Release Note

JA/S 4.SMI.1M SMI Shutter Actuator, 4-fold, Manual Operation, MDRC

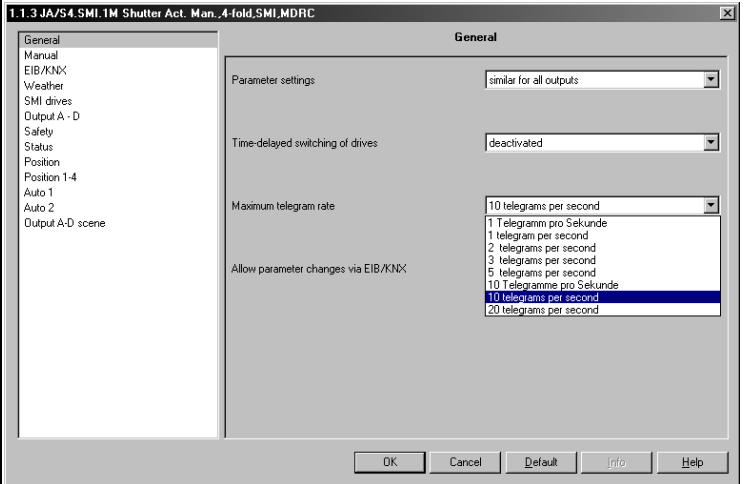
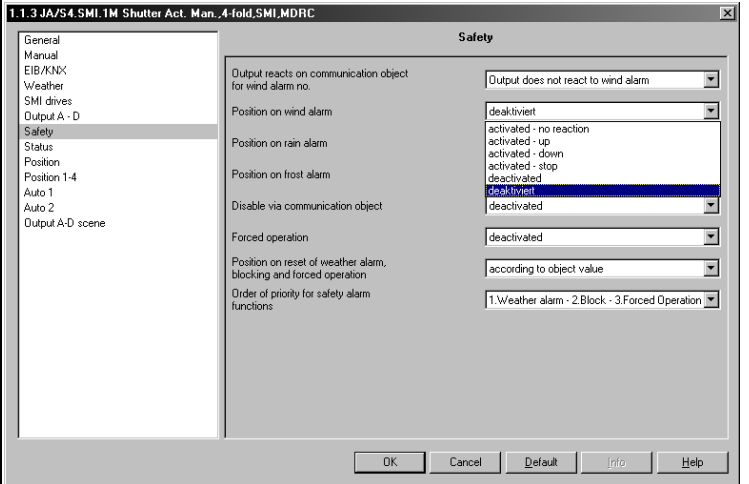
Product Type	Version	Since	Updates and Release Notes
JA/S4.SMI.1M	1.5	10/2023	Due to a change of the device functionality the moving of the hanging at bus voltage failure is no longer possible and the hanging stays in ist current position or will finish a already started moving command. The parameter Behavior at bus voltage failure was adapted accordingly and the selection of an option is no longer possible.
JA/S4.SMI.1M	1.3a	02/2021	Change of the ETS catalog structure. No further changes to the previous version
JA/S4.SMI.1M	1.3	08/2017	Error correction: End of commsioning due to flawed detection of to many motors Error during automatic adresssing was fixed. Attention: Starting from manufacturing date 2011 (January 2021) there has been a change of the devices. Through this a moving of the hanging at bus voltage failure is no longer possible and the hanging stays in its current position/will finish its already running moving command.
